Access Compliance Report

Public Rights-of-Way

(Pedestrian Signals)

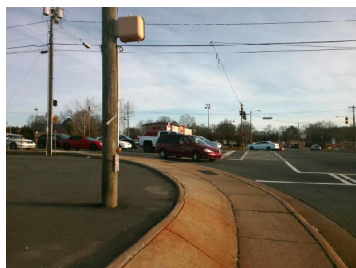
Surveyor Notes: BUTTON IS COMPLETELY INACCESSIBLE TO HANDICAPPED

PROW/ADA: TMUTCD 4e.08, R404.2, R404.3, R404.7.3, R404.7.2

Possible Solutions: Replace Signal Push Button With APS Button on New Post. Remove & Relocate Sign.
